RECOMMENDATION MEETING

3435 15th Ave W  
Seattle, WA 98119

3040787-LU  
3040822-EG

09.04.2024

FIGURE 4: CIRCULATION DIAGRAM

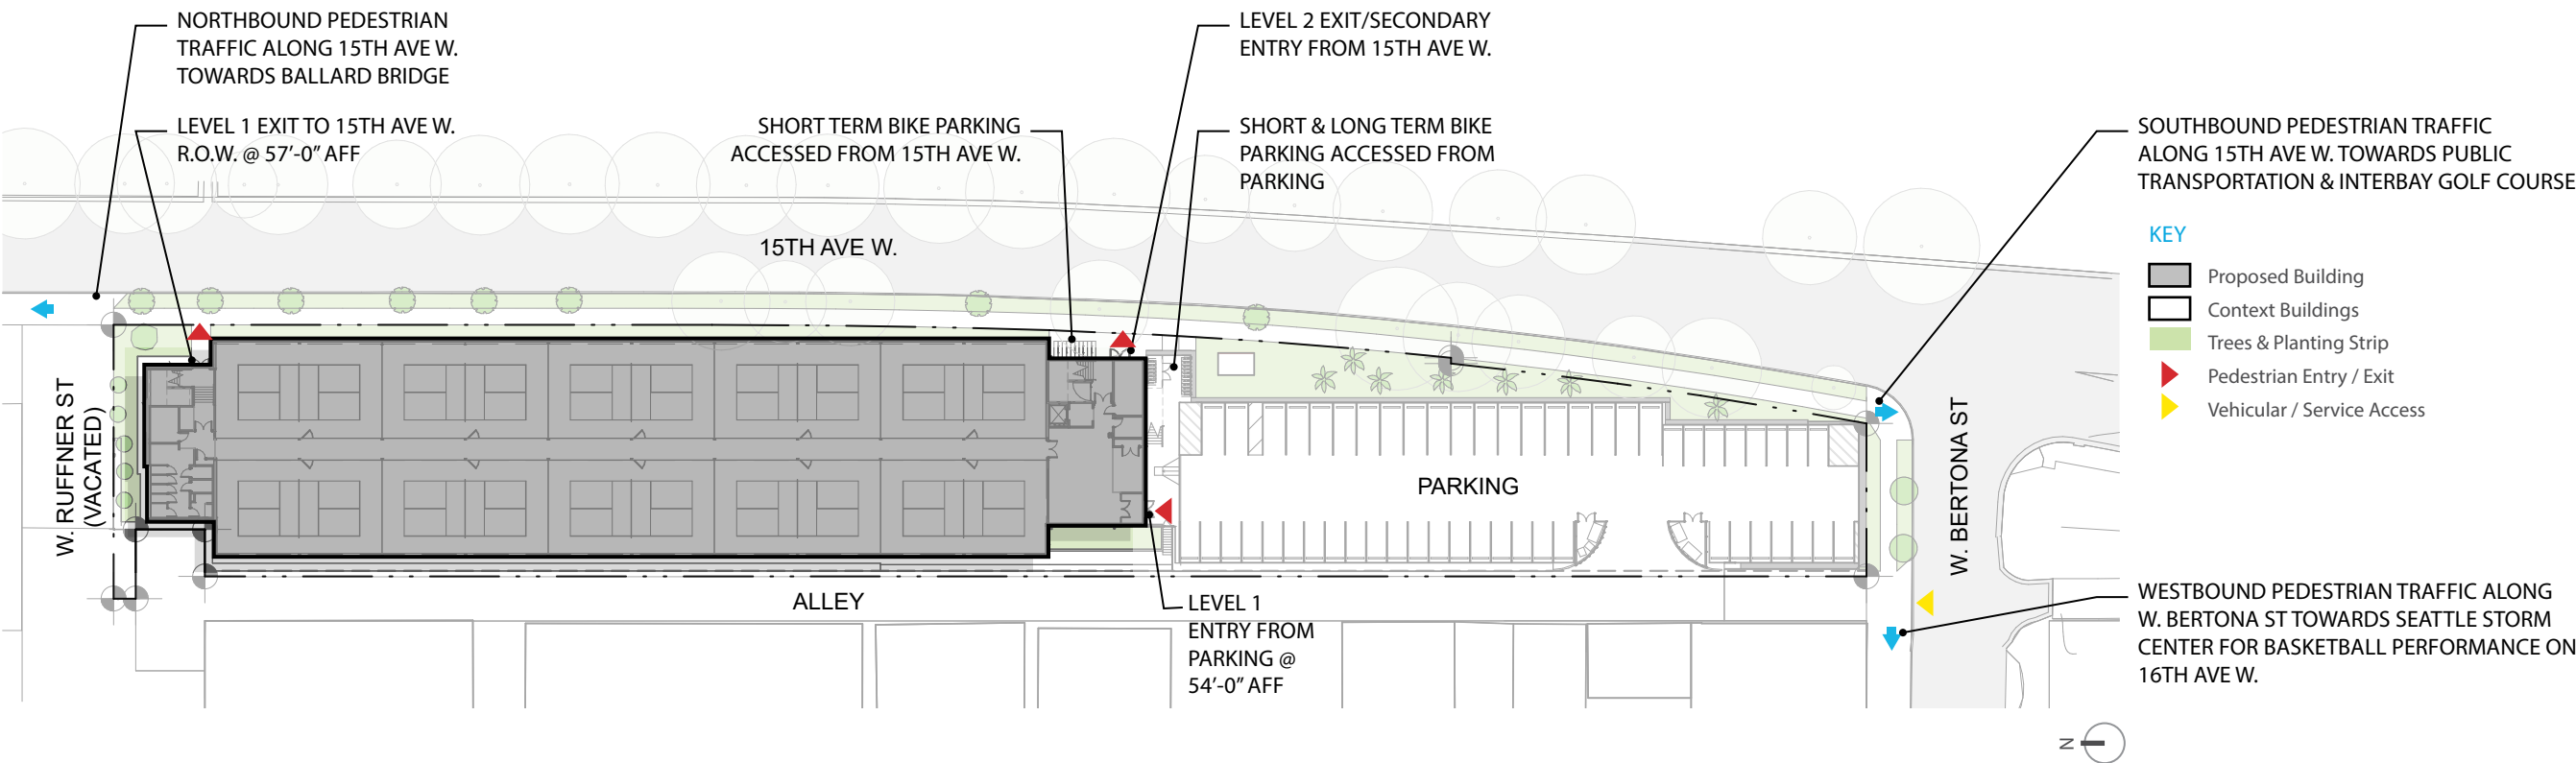
The Board gave guidance to create identifiable entries that are accessible to all visitors. (PL3-A Entries, PL2-A-1. Access for All, PL2-D Wayfinding)

- The project has one main entry accessed from parking on level 1. This is due to a security reason from the operation standpoint. There are two required exits fronting 15th Ave W. The north exit is intended for exiting only. The south exit, with its storefront wall and door, can be used as an accessible pedestrian entry from 15th Ave W.
- Canopy, signage, oversized pickleball graphics, and ample glazing are used collectively to identify the main entry from parking. Similar elements are utilized for the south exit/secondary entry from 15th Ave W., in addition to the landscape strips leading pedestrians from both north and south to this entry on the street level. Lighting will be provided to accentuate both entries at night.
